ADDENDUM NO. 02
TO
SPECIFICATIONS AND CONTRACT DOCUMENTS
FOR
INVITATION TO BID
DPMT SHORELINE PROTECTION
JPA CONTRACT NO. C-1806

PRE-BID MEETING MINUTES
JPA Contract: ITB C-1806
DPMT SHORELINE PROTECTION

**INVITATION TO BID
ADDENDUM NO. 02
JPA CONTRACT NO.: C-1806
DPMT SHORELINE PROTECTION**

C-5
 SHEET 5 OF 11

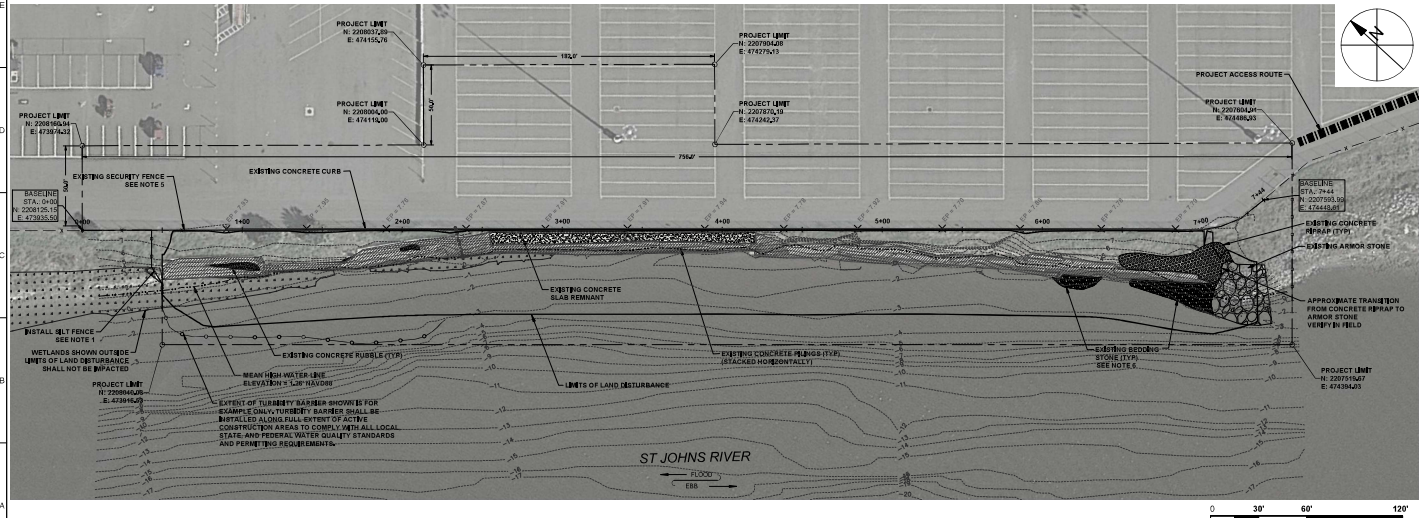
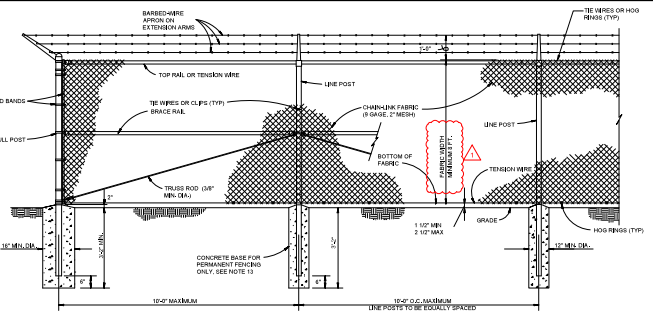
Reference to Drawing C-5 Note 4 **REMOVE** “...THE CONTRACTOR SHALL ASSUME THAT NO MORE THAN 100 CY OF IMPORT FILL MATERIAL OR 100 CY OF DISPOSAL OF EXCESS CUT AND/OR UNSUITABLE MATERIAL. TO/FROM AN OFF-SITE LOCATION WILL BE REQUIRED.” and **REPLACE** with **Drawing C-5 Note 4 “...THE CONTRACTOR SHALL ASSUME THAT NO MORE THAN 200 CY OF IMPORT FILL MATERIAL OR 200 CY OF DISPOSAL OF EXCESS CUT AND/OR UNSUITABLE MATERIAL. TO/FROM AN OFF-SITE LOCATION WILL BE REQUIRED.** (See attachment No. 06)

4. Drawing C-5 note 4 says we're assume 100 CY of import & 100 CY of disposal of excess cut material but the bid form page BF-1 shows 200 CY of import & 200 CY of disposal of excess cut material. Which is correct?

5. Drawing C-5 note says existing security fence and/or gates may be removed for access and that the contractor is responsible for furnishing & installing new permanent fencing and/or gates where they were removed. Is new security fencing required for the entire length of the active work zone STA 0+00 to 7+44 even if not all of that area was removed?

ANSWER: For bidding purposes, the Bid form (BF-1), is the correct quantity with 200 CY of import & 200 CY of disposal. (See Attachment No. 04)

ANSWER: *Per note 5, on pages C-5; For bidding purposes, the contractor shall assume the removal and replacement of the permanent security fence from station 0+00 to 7+00.*

- UPON COMPLETION OF DEMOLITION, REMOVAL AND DISPOSAL OF SOLID DEBRIS AND PRIOR TO EARTHWORK, THE CONTRACTOR SHALL SUBMIT A PRE-CONSTRUCTION SURVEY TO ESTABLISH PRE-CONSTRUCTION GRADES AND VERIFY EARTHWORK QUANTITIES. FOR BID PURPOSES, THE CONTRACTOR SHALL ASSUME THAT NO MORE THAN 200 CY OF IMPORT FILL MATERIAL OR 200 CY OF DISPOSAL OF EXCESS CUT AND/OR UNSUITABLE MATERIAL TO FROM AN OFF-SITE LOCATION WILL BE REQUIRED.

- THE EXISTING SECURITY FENCE MAY BE REMOVED AS NECESSARY TO ALLOW FOR EASE OF ACCESS TO THE PROJECT SITE. THE CONTRACTOR SHALL BE RESPONSIBLE FOR FURNISHING AND INSTALLING NEW PERMANENT SECURITY FENCING AND/OR GATES WHERE EXISTING FENCING AND/OR GATES WERE REMOVED. PRIOR TO REMOVAL, THE CONTRACTOR SHALL COORDINATE WITH THE ENGINEER ON SECURITY REQUIREMENTS AND SUBMIT A FENCING PLAN FOR REVIEW AND APPROVAL. FOR BEDDING PURPOSES, CONTRACTOR SHALL ASSUME THE REMOVAL AND REPLACEMENT OF PERMANENT SECURITY FENCING FROM STATION 0+00 TO 7+00.

C-10
SHEET 15 OF 11

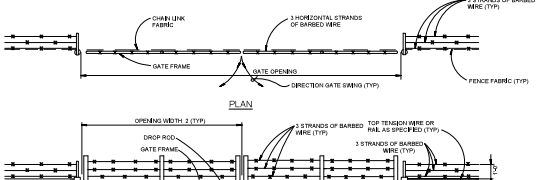
3. Please verify the required temporary and permanent fence height?

6. Is there a specification available for the Security Perimeter Fence?

ANSWER: Both temporary and permanent security fencing are to be a minimum of 8' tall fabric with an additional 1' in height provided by the 45-degree extension arms with 3 strands of barbed wire attached.

ANSWER: There is no Technical Specification section for fencing, see additional information provided in question 3 and Sheet C-10 for the remaining information. **(See Attachment No. 06)**
